Docket Item #5
BAR CASE #2016-00269

BAR Meeting
September 7, 2016

ISSUE: Waiver of Rooftop HVAC Screening at the Lyles-Crouch School

LOCATION: 530 South Saint Asaph Street

Figure 1: Pictometry view of the roof looking south

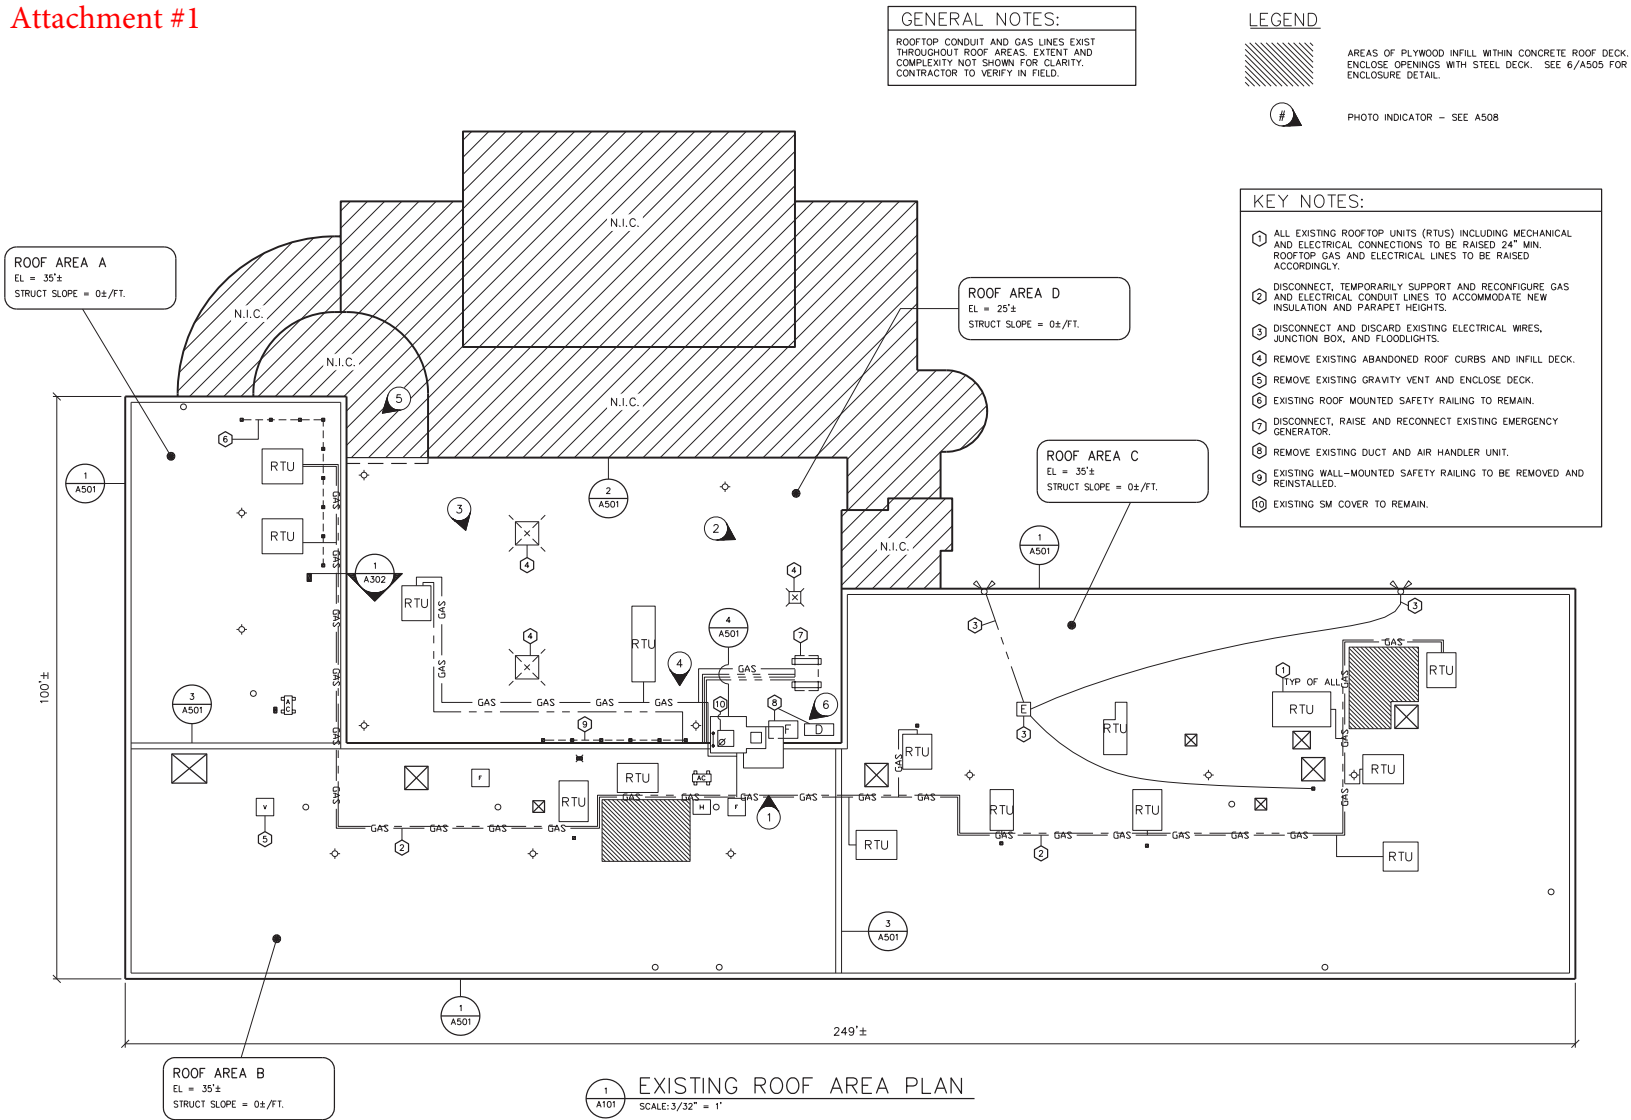
In the opinion of Staff, the proposed HVAC alterations are acceptable. Currently, several pieces of existing rooftop equipment are visible in views from the north along South Saint Asaph, South Pitt, and Wilkes streets and from the school grounds. The view from the south is considerably more restricted. While raising the equipment another two feet (18"-24") will make the RTUs more visible, Staff has been assured by the applicant that the units are located as far from the roof edge as possible and notes that the units are visible only at a distance from the building.

In the opinion of Staff, rooftop screening of the equipment would not be beneficial in this case. The units are not grouped together but are scattered throughout the roof. Metal mechanical screen walls could be added around each of the visible units, but the screen walls would have to be set off from the equipment by approximately three feet (3') to allow access for maintenance.

Alternatively, the entire roof area could be screened at the perimeter by a metal false-mansard roof like those once used on strip shopping centers and recently removed from 1201 North Washington Street. In addition to being stylistically inappropriate on this Modernist style building, staff believes the bulky screens would only increase the appearance of mass on the flat rooftop and

serve to draw more attention to the intrusions. Finally, the color of the existing HVAC units is already a light gray and blends with the Virginia sky, rather than trying to make the units brick red and part of the architecture. Therefore, Staff recommends approval of the request for Waiver of Rooftop HVAC Screening.

Staff recommends approval of the application as submitted.
